Aillio Technology Co., Ltd

We recently discovered that there's a step missing in the installation guide. The cooling tray connector has changed from 5-pin to 3-pin:

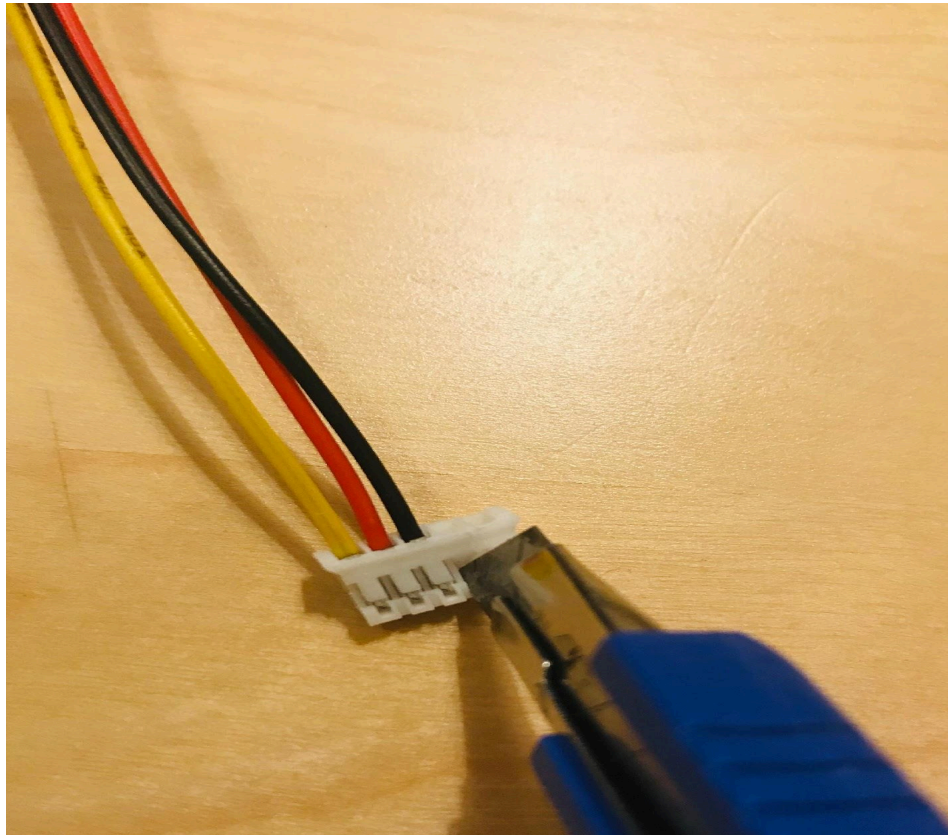
It's easy to mod the previous 5-pin connector to a 3-pin one: you only need to use a knife or razor to cut off the two unused slots on the connector. Because there are two extra slots, you can practice on the first slot, get a feel for it, and then remove the second slot.

Please make sure you insert the knife at the correct position, leaving a 'wall' for the black wire:

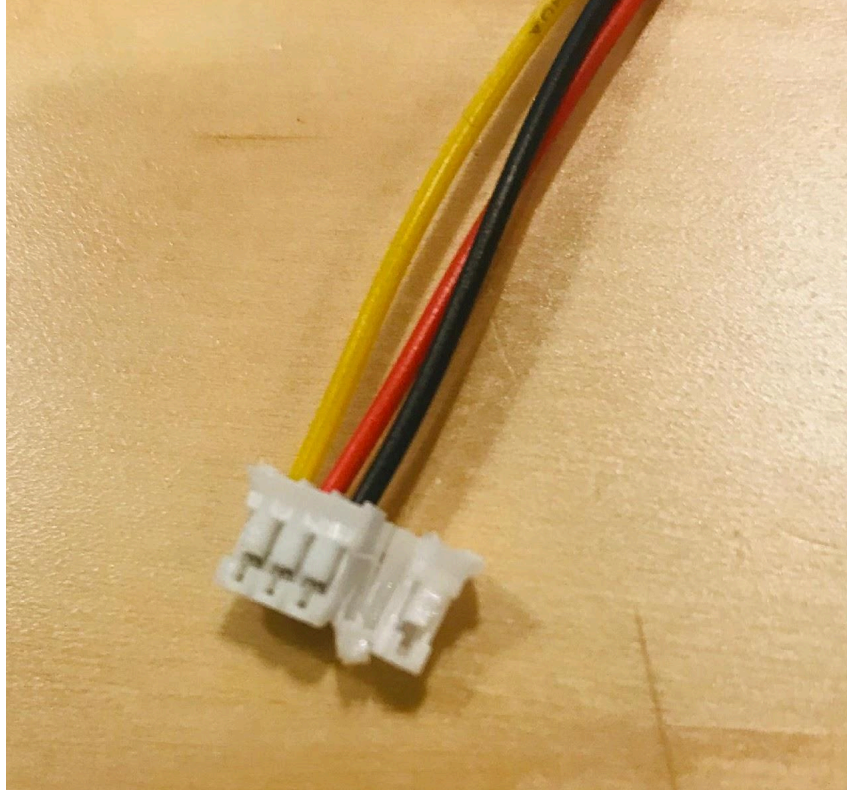
As you cut, it should look like this:

There may be some loose plastic on the side. You can clean it up with the sharp edge, so that it can be fitted into the 3-pin connector.
